## DESIGN REVIEW BOARD MARCH 17, 2017

ALPHARETTA CITY HALL  
COUNCIL CHAMBERS  
2 PARK PLAZA  
8:30 AM

**2. 09:15 - 09:45 DRB170005 Zyka 3800 Brookside Pkwy**  
review landscape and additional details on other plans

**7. 11:20 - 11:45 DRB 160081 Courtyard by Marriott 11700 Amberpark Dr**  
review corner feature and landscape

sheet number  
L-1.0

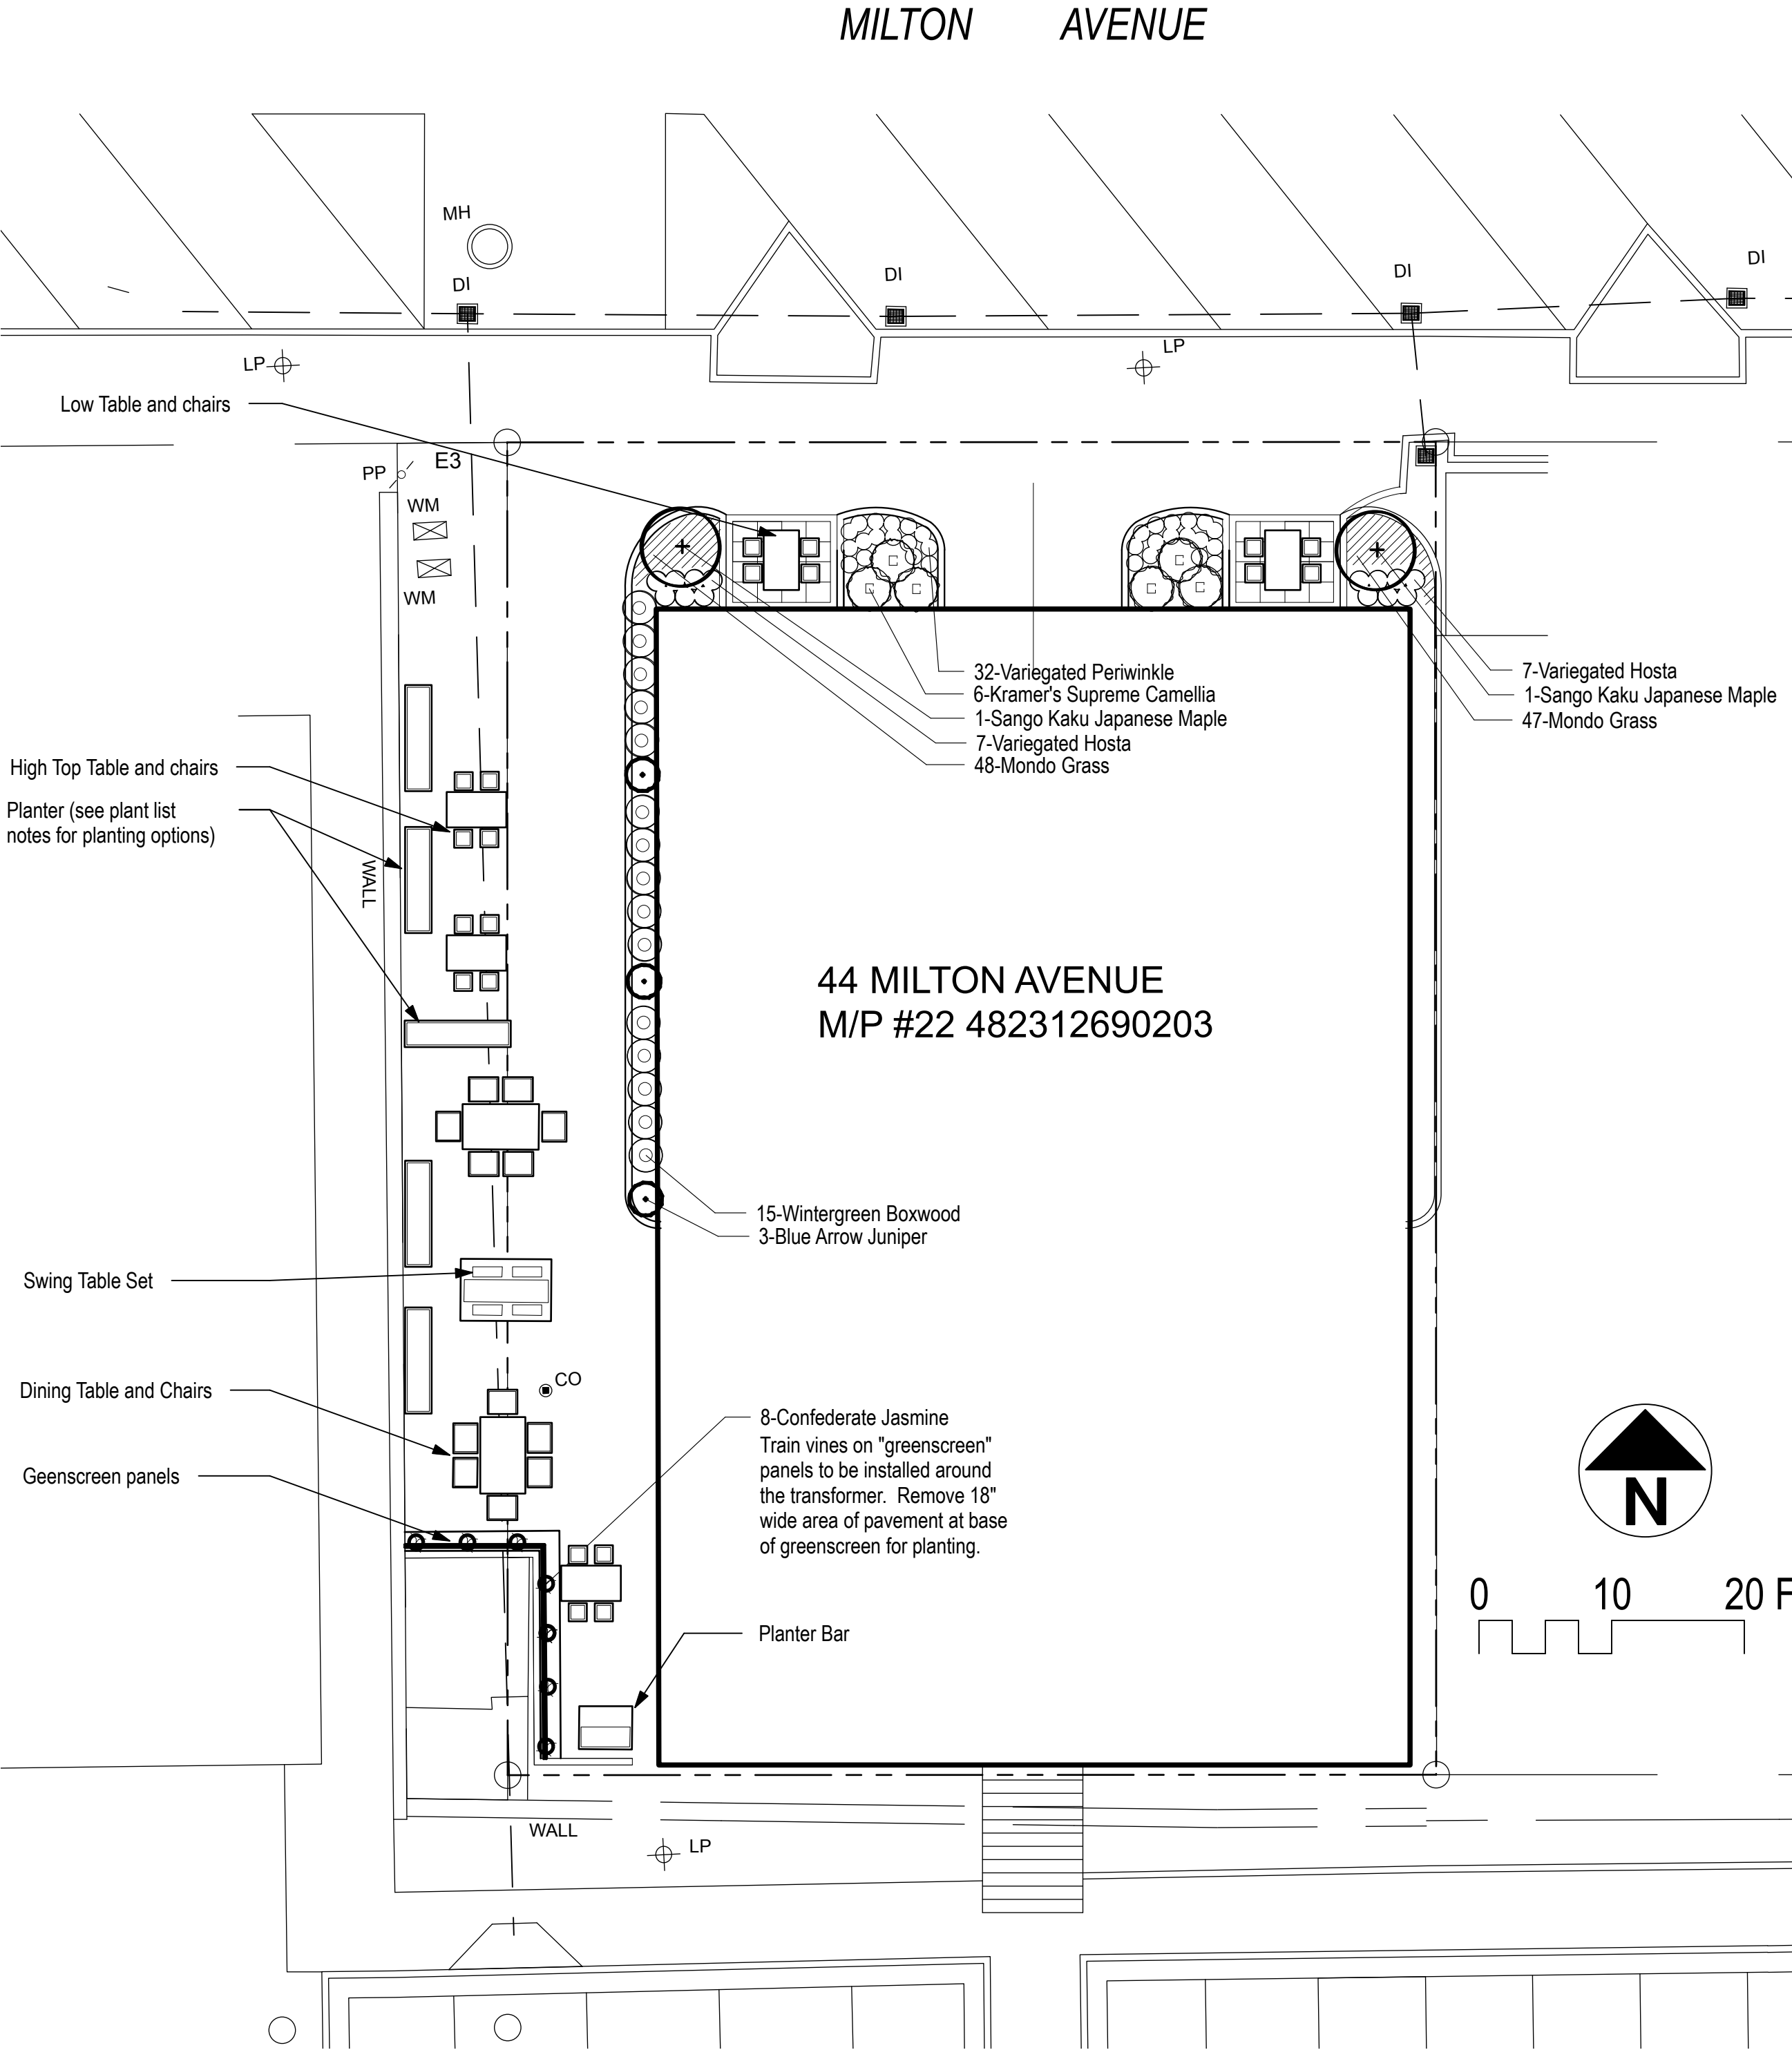
- Riverbirch is not recommended as a tree near a dining area. These are messy trees and will be problematic. Why can't the existing tree stay? Any tree to be planted needs to be a single stem standard and meet the definition of a shade tree from our new ordinance. Verify that the open soil surface is 200 sq ft.
- Shrubs along edges should create a solid hedge. Osmanthus up front is okay.
- 3 gal plant material is way too small.
- I am not sure English ivy is a good idea. It has been proven to be good rodent habitat.
- Not everything is labelled.
- Replace lost tree with 2 shade trees over parking and I need to know where they are going.
